Staff Report PC16-028-PP

Whitestown Business Park – Primary Plat/Replat

Docket PC16-028-PP – Primary Plat/Replat – Whitestown Business Park. The petitioner is requesting approval of a replat of the primary plat to be known as Whitestown Business Park. The subject property is currently zoned I-1 Light Industrial and is approximately 158 acres. This property is located on the west side of SR 267, across from Perry Industrial Park. The petitioner is Exeter Property Group and the project engineer is Innovative Engineering.

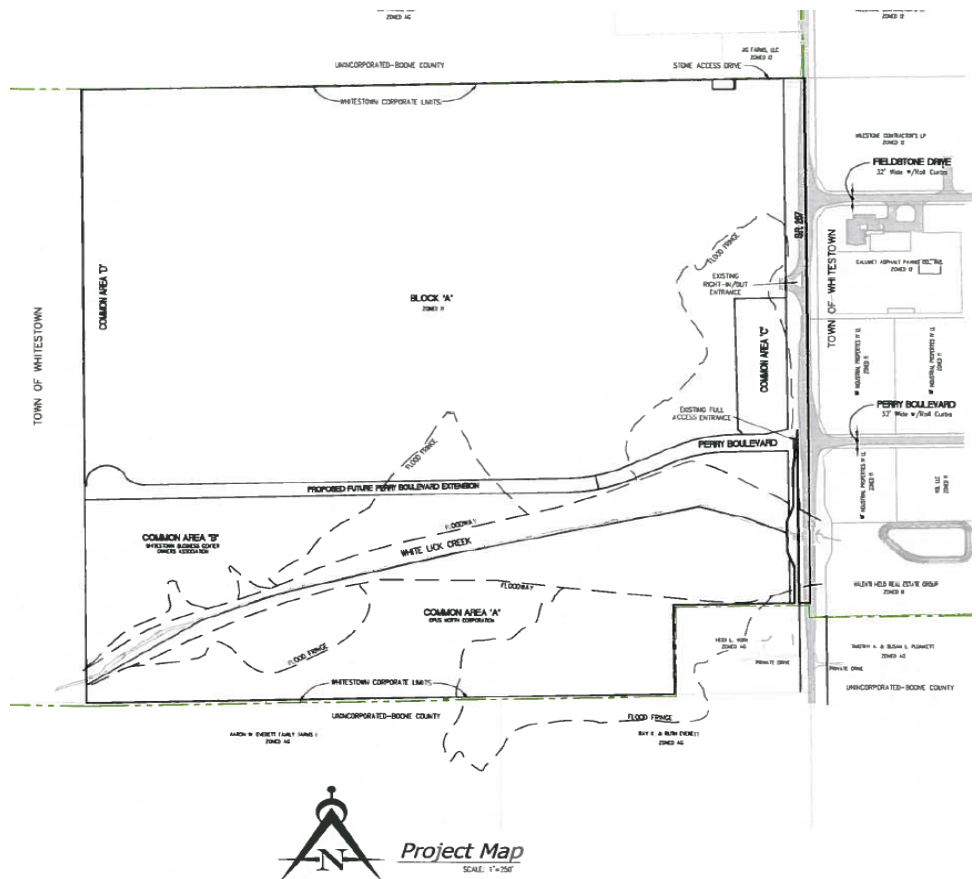
- This replat redesigned the access road to run straight through the site to better access and develop a variety of building sizes,
- Public utilities will be run throughout the site and offer potential hook up upon development of the property to the west.
- Written commitment from 2015 Primary Plat states the following:

“Provide a written commitment when and if the Town takes over SR267 to fund 100% the installation of a traffic signal at the intersection of SR267 and the Perry Boulevard extension across the property.”

Staff recommends that the WPC approve the Primary Plat/Replat for the Whitestown Business Park.
